UNITED STATES PATENT AND TRADEMARK OFFICE

Office Action Summary

10/628,164

NORO, YUTAKA

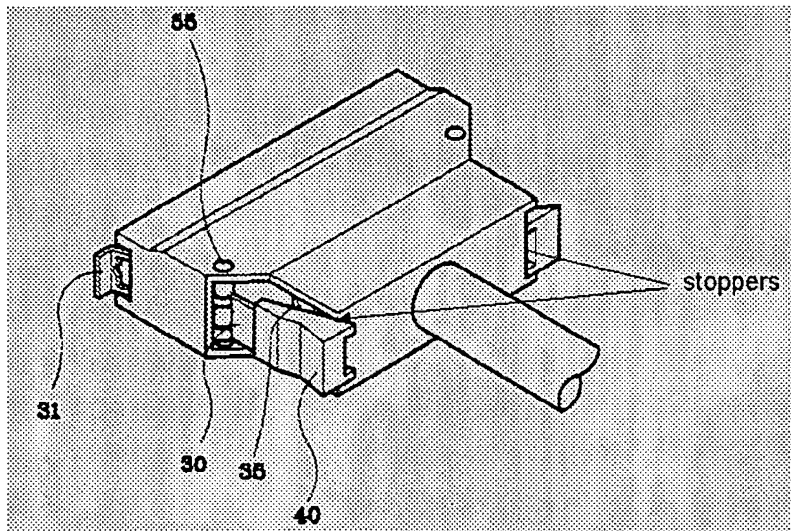
Regarding claim 3, Chang discloses the movable member deforming the resilient locking piece by a levered action using a rotatable shaft (55/65) as a fulcrum during rotation. Please note that the levered action of the movable member (40) deforms the resilient locking piece at least at 35.

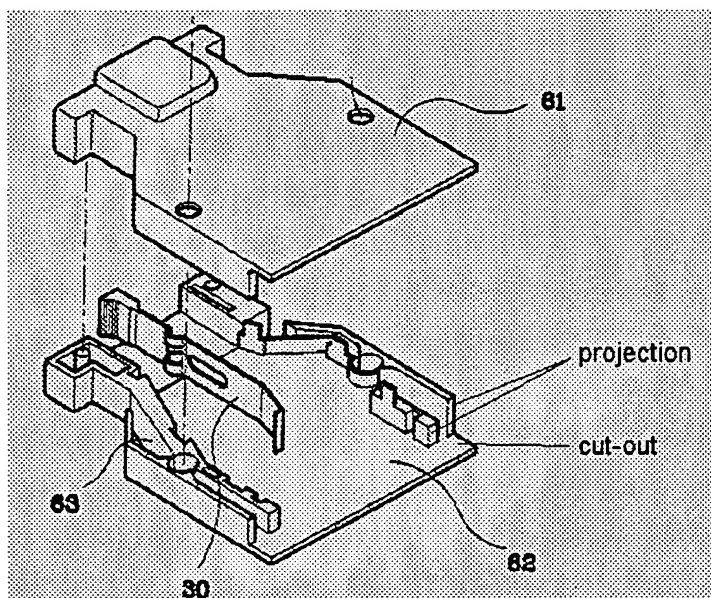
Regarding claim 4, Chang discloses the housing comprising at least one stopper (see following figure) for preventing the resilient locking piece from being excessively deformed beyond the unlocking posture by contacting the movable member when the movable member is operated to deform the resilient locking piece into the unlocking posture.

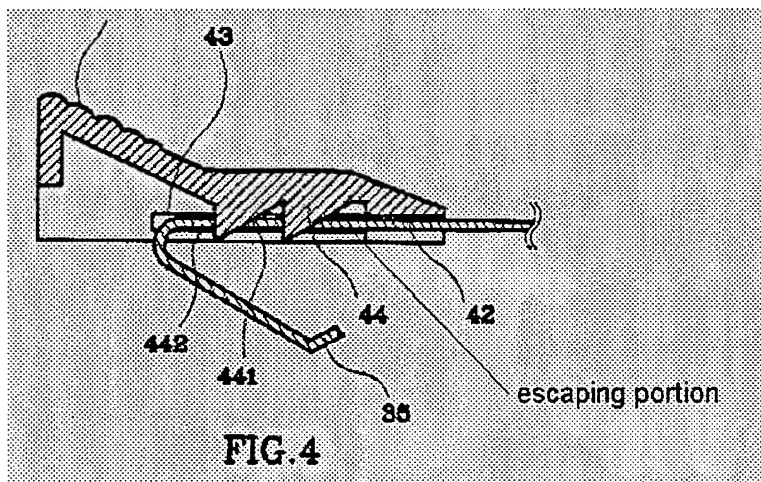
Regarding claim 6, Chang discloses the movable member (60) comprising at least one escaping portion (see following figure) into which the resilient locking piece (at

lease end 35) escapes when being moved between the locking posture and the unlocking posture. Please note that portion 35 of the resilient piece can escape into the portion of the movable member (40) shown below.
